Reply to the comments of the Anonymous Referee #1.

"Full HAWT rotor CFD simulations using different RANS turbulence models compared with actuator disk and experimental measurements".

Figure 1. Residuals of the full-rotor CFD simulations using the RNG k-ε turbulence model.

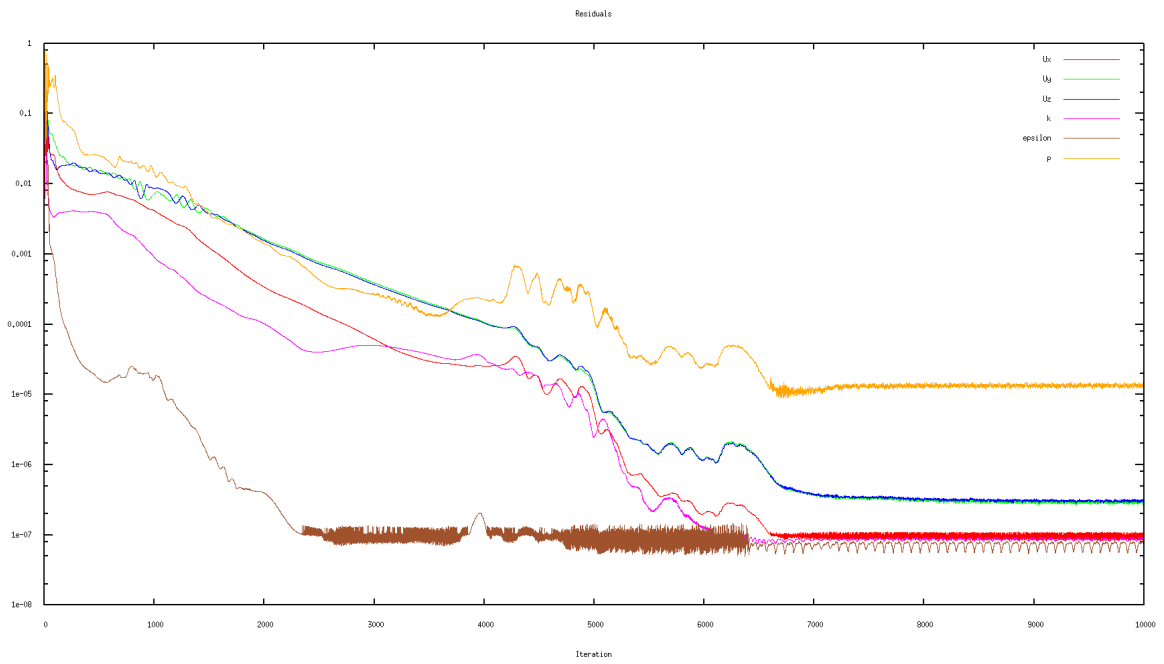
"Really?? And that for a residual reduction of only 4 orders of magnitude??
At this number of iterations, why not do DES – these would typically require between 10000
and 100000 time steps?"

Residuals converged for all cases after 6000 iterations. The residual reduction for pressure was four and in some cases five orders of magnitude which is commonly accepted for industrial applications. Second order numerical schemes were used in all cases. An example of the residuals for the case of full-rotor CFD simulation, using the RNG k-ε turbulence model is given in Figure 1 (please see the appendix) and has been included in the manuscript.

An example of the residuals for the case of full-rotor CFD simulation, using the RNG k-ε turbulence model is given in Figure 10 of Appendix 2.

Figure 2. Results of the full-rotor CFD simulations including the nacelle and tower.
Top: mid wake (5.18D), bottom: far wake (8.5D).

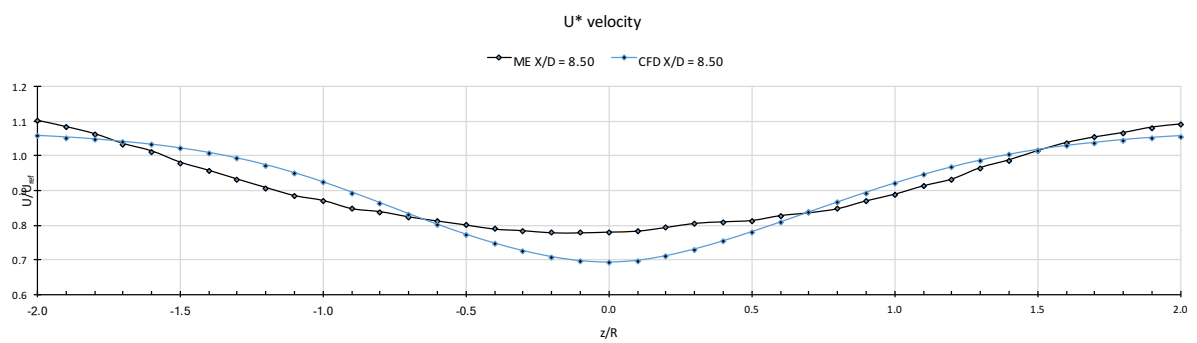
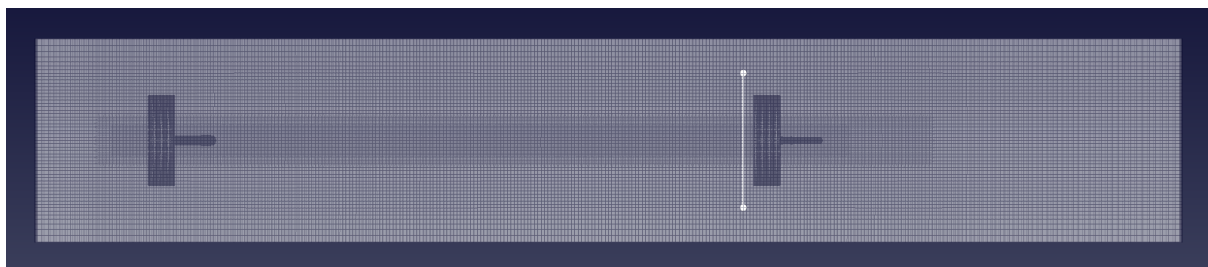
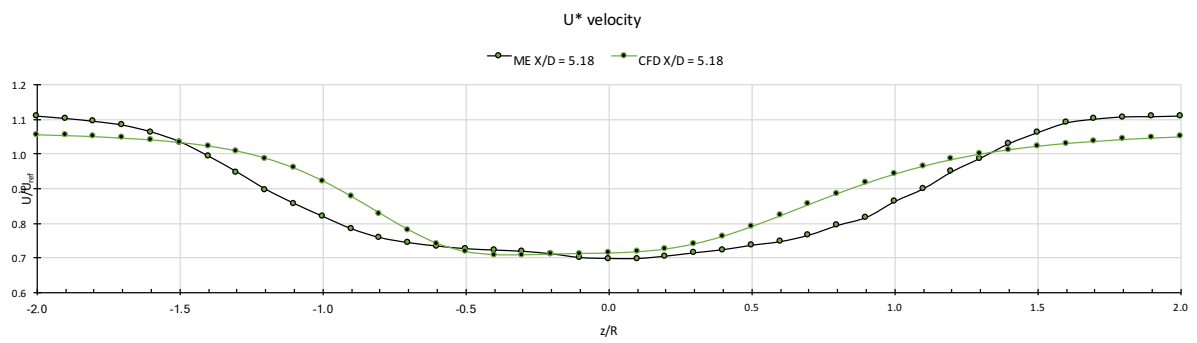
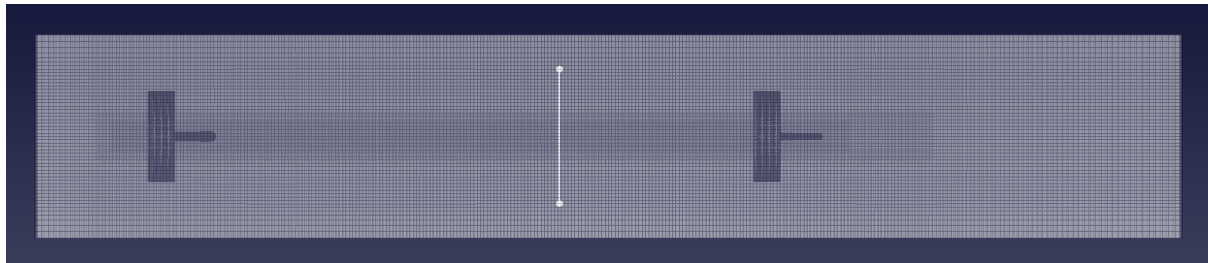
Comment 6
Page 18.
"It is concluded that the k-omega models are the best. Unfortunately, no tower or nacelle is modelled, so not sure that this conclusion will hold one you should add them."

Answer:
It is true that from the current research outcome for the blade-resolved CFD approach, is that the group of k-ω models performed better. Preliminary results with nacelle and tower suggest that this is always the case, but, as already mentioned in the manuscript, this topic needs further investigation
